Nine Mile Point Nuclear Station

License Renewal Application – Responses to Previously Unanswered NRC  
Requests for Additional Information (TAC Nos. MC3272 and MC3273)

#### List of Unanswered RAIs When the Grace Period Commenced

#### Responses to NRC Requests for Additional Information (RAIs) Related to:

## Part B

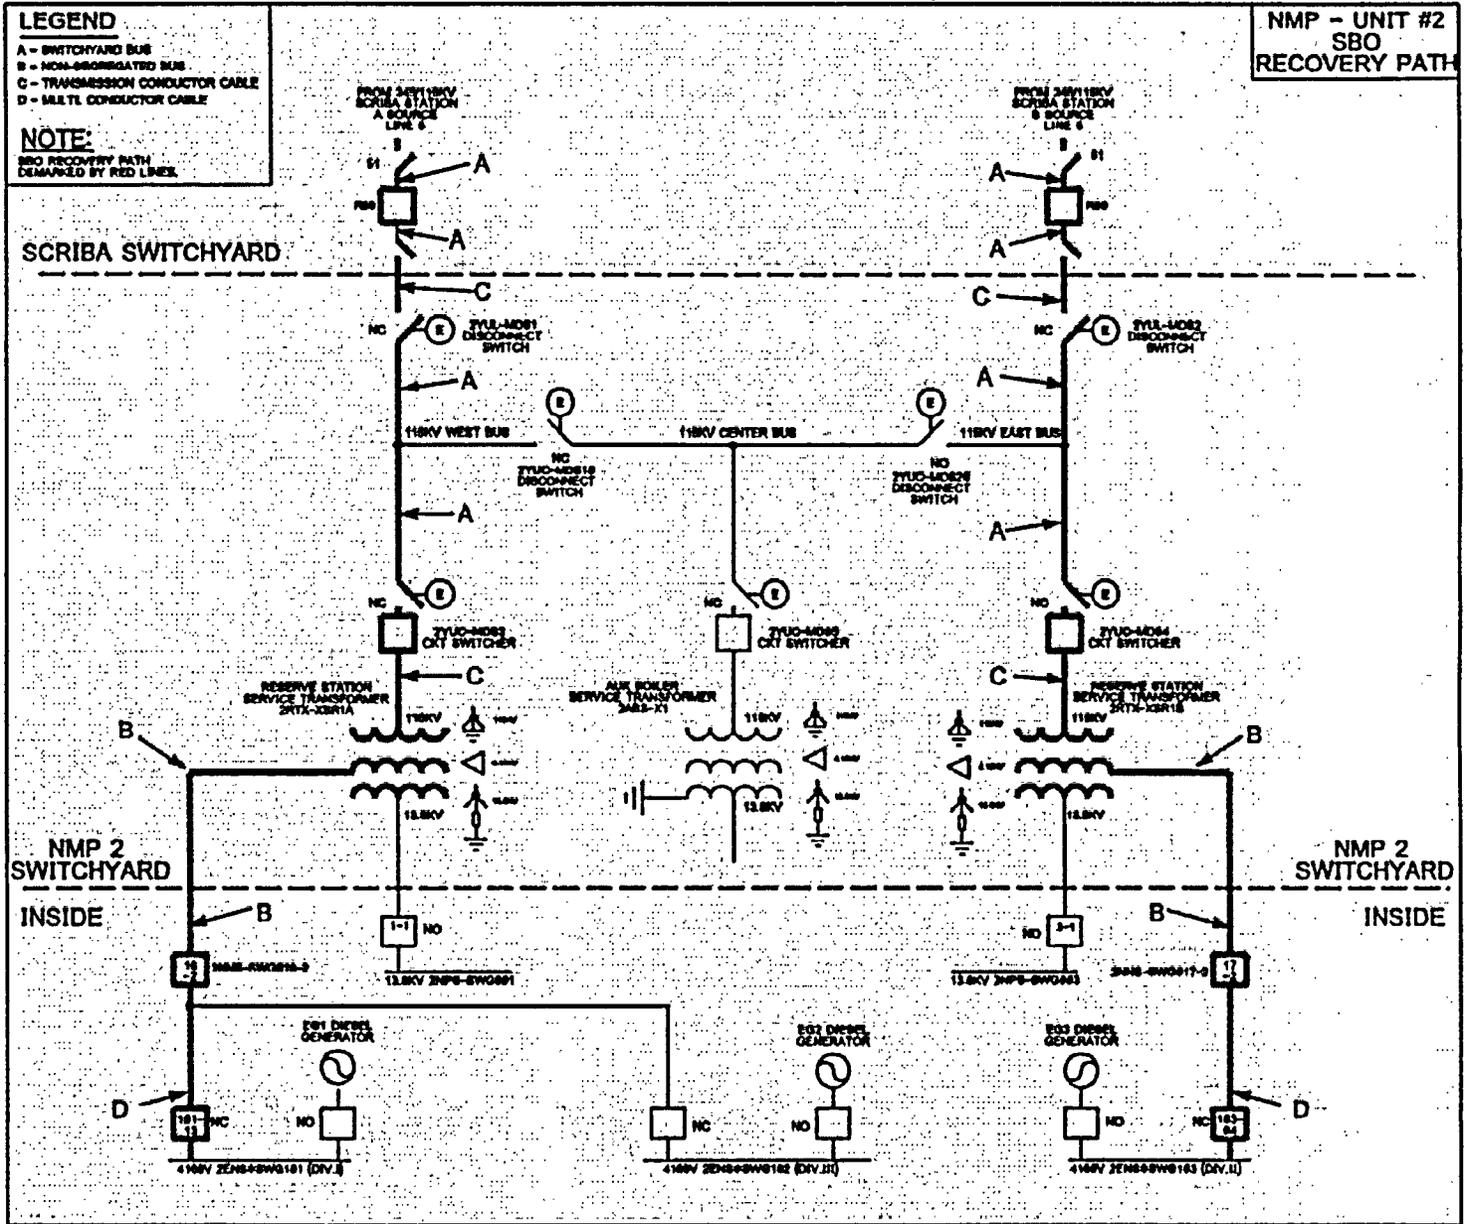
- A. *Please provide a detail description of the NMP recovery path and discuss how the recovery path is consistent with scoping and screen results described in Section 2.5 of the LRA. Also, please provide a one line diagram with redline showing the recovery path of Station Blackout (SBO).*

Diagrams of the NMP1 and NMP2 offsite circuits with the SBO path shown in bold are attached. These diagrams correspond to the descriptions of the SBO recovery path provided below. The identification of each commodity group component, as requested in Item B of the RAI, is included in the unit specific Part A response.

The commodity group component types in the NMP1 and NMP2 SBO recovery path circuits are identified on the attached one line diagrams. These commodity group component types are switchyard bus, non-segregated bus, overhead transmission conductor and multiple conductor cable.

The control circuit wiring associated with the NMP1 and NMP2 SBO recovery path circuits is included in the electrical commodity group of Cables and Connectors (LRA Section 2.5.C.1).
